**SUBJECT: LIMERICK GENERATING STATION, UNITS 1 AND 2 – ISSUANCE OF
AMENDMENT NOS. 232 AND 195 TO REVISE TECHNICAL SPECIFICATIONS
TO LOWER THE MINIMUM STANDBY LIQUID CONTROL SYSTEM PUMP
FLOWRATE (EPID L-2018-LLA-0020)**

AMENDMENT TO RENEWED FACILITY OPERATING LICENSE

SAFETY EVALUATION BY THE OFFICE OF NUCLEAR REACTOR REGULATION
RELATED TO AMENDMENT NO. 232 TO
RENEWED FACILITY OPERATING LICENSE NO. NPF-39 AND
AMENDMENT NO. 195 TO RENEWED FACILITY OPERATING LICENSE NO. NPF-85
EXELON GENERATION COMPANY, LLC
LIMERICK GENERATING STATION, UNITS 1 AND 2
DOCKET NOS. 50-352 AND 50-353

FIGURE 3.1.5-1

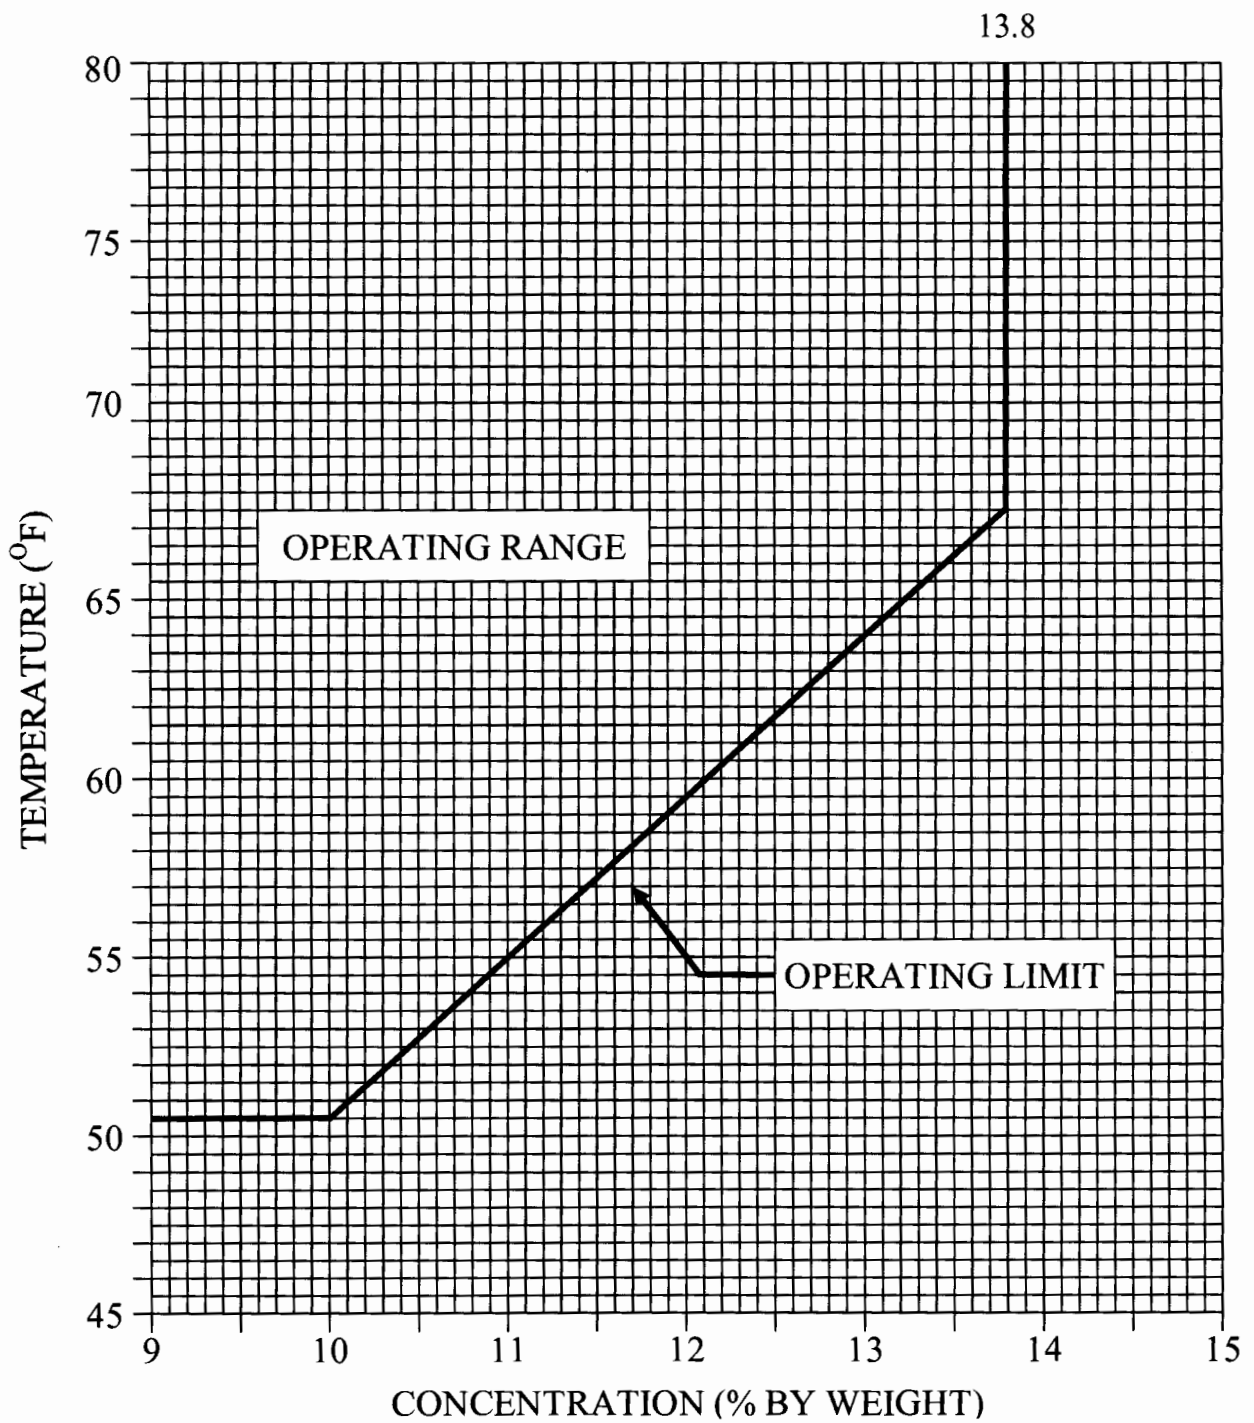
- TS 3/4.1.5, "Standby Liquid Control System," Figure 3.1.5-1, "Sodium Pentaborate Solution Temperature/Concentration Requirements," would be revised to provide a new figure. The new figure would extend the minimum operating range limit for the sodium pentaborate concentration from 10 percent to 9 percent, while retaining the lower temperature limit of 50.5 degrees Fahrenheit ($^{\circ}$ F).

The licensee proposed to revise TS 3/4.1.5, Figure 3.1.5-1. The new figure would extend the minimum operating range limit for the sodium pentaborate concentration from 10 percent to 9 percent, while retaining the lower temperature limit of 50.5 °F. The staff finds this acceptable because it will improve operational flexibility while continuing to confirm that the SLCS tank contents meet the TS limits.

Based on the above evaluation, the NRC staff finds that the proposed TS change to SLCS minimum sodium pentaborate solution concentration from 10 percent to 9 percent is acceptable

because it still maintains a considerable margin of sodium pentaborate solution available (3,160 gallons) to meet the AST analysis requirement (1,786 gallons).
